**R66 SERVICE BULLETIN SB-07**

**DATE:** 03 July 2013

**SUBJECT:** Throttle Control Routing

**ROTORCRAFT AFFECTED:** R66 helicopters S/N 0004 thru 0394 except 0097, 0169, 0174, 0187, 0199, 0233, 0258, 0265, 0266, 0267, 0276, 0279, 0280, 0283, 0284, 0287, 0288, 0291, 0292, 0293, 0295, 0296, 0311, 0312, 0317, 0325, 0326, 0342, 0343, 0347, 0350 thru 0357, 0367, 0368, 0372, 0373, 0374, 0378, 0380, 0388, 0391, 0392, & 0393.

**FIGURE 1: Suggested template for maintenance aid.**

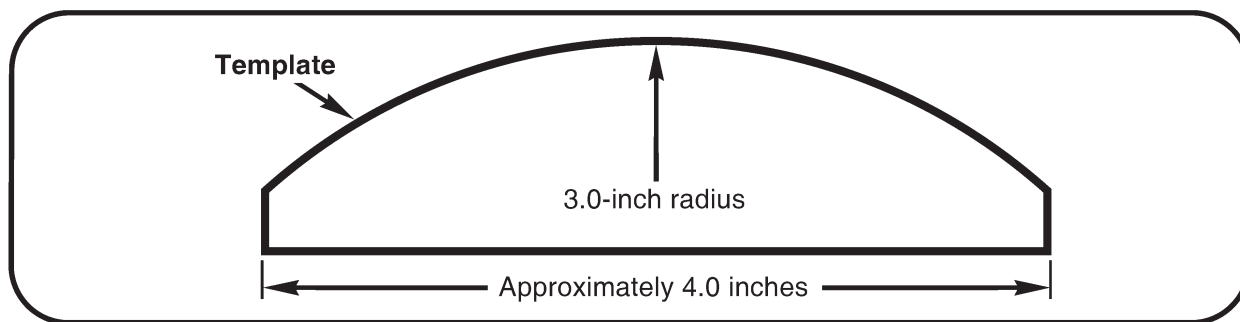
1. Refer to R66 Maintenance Manual (MM) § 6-70. Remove F461-1 (collective cross tube) and F463-1 (mid tunnel) cover assemblies.
2. Fabricate a 3.0-inch radius maintenance aid from sheet metal or wood (refer to Figure 1 for suggested template).

**FIGURE 2: View of C522-10 Throttle control in mid tunnel.**

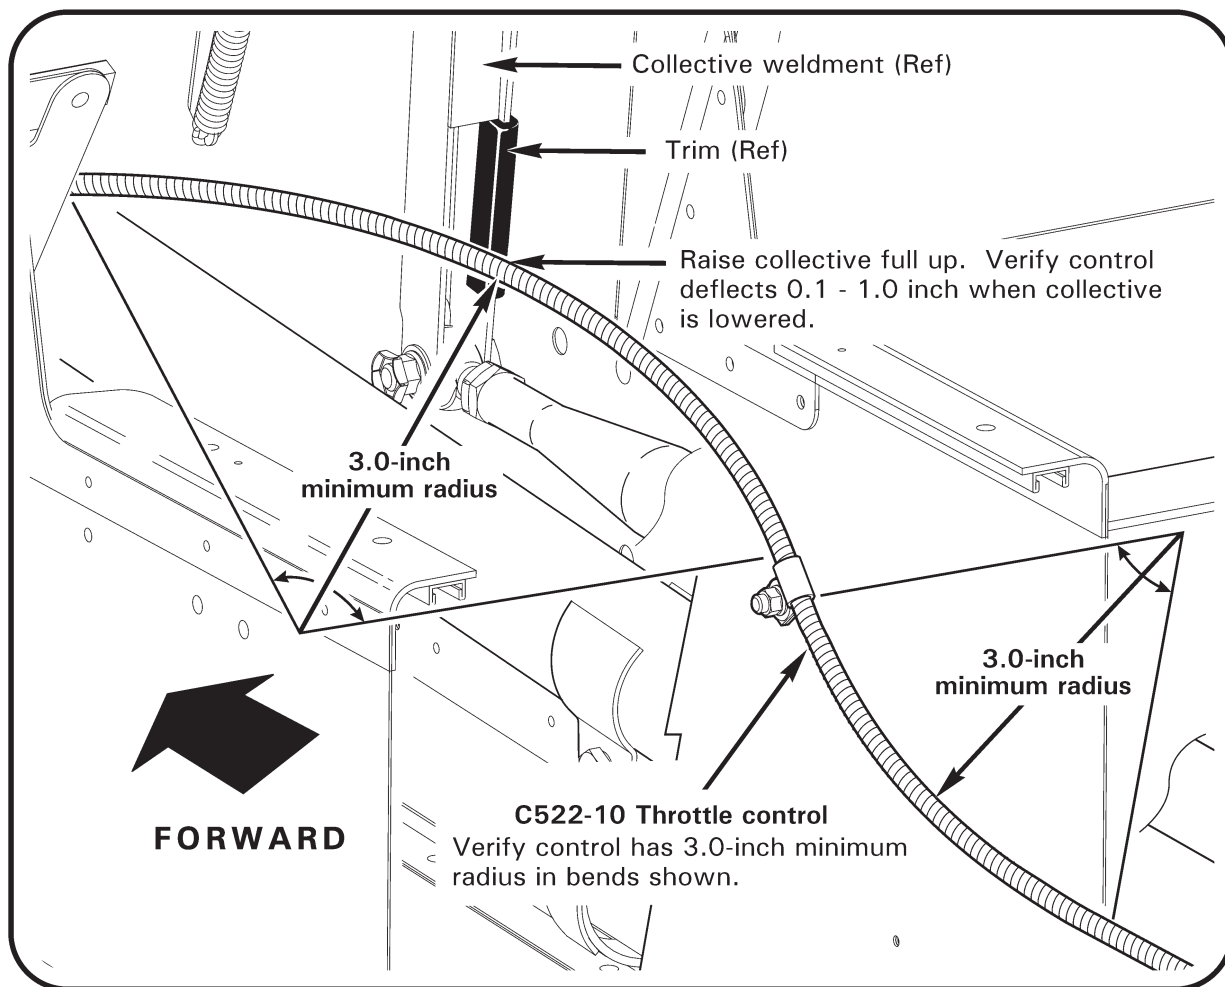
**BACKGROUND:** RHC has received a report of a broken C522-10 control's inner wire, causing a loss of throttle control. The control wire broke near a mounting clamp where the control was routed with a sharp bend. This bulletin requires verifying the control is not damaged and that control bends have a minimum radius.

3. Refer to Figure 2. Using maintenance aid, verify C522-10 control has 3.0-inch minimum radius in bends shown. If required, loosen hardware securing adjacent clamps and adjust housing position in clamps. Tighten hardware and repeat step until bend radii are within limit.

4. If control routing was adjusted in previous step, due to a sharp bend, replace control's inner wire (P/N SSW-050-C522-10) and rig throttle control per MM § 76-11.

5. Raise collective full up. Verify control deflects 0.1-1.0 inch at trim on weldment when collective is lowered. If required, loosen hardware securing adjacent clamps and adjust housing position in clamps. Tighten hardware and repeat step until deflection is within limit. Maintain 3.0-inch minimum radius with collective up and down.
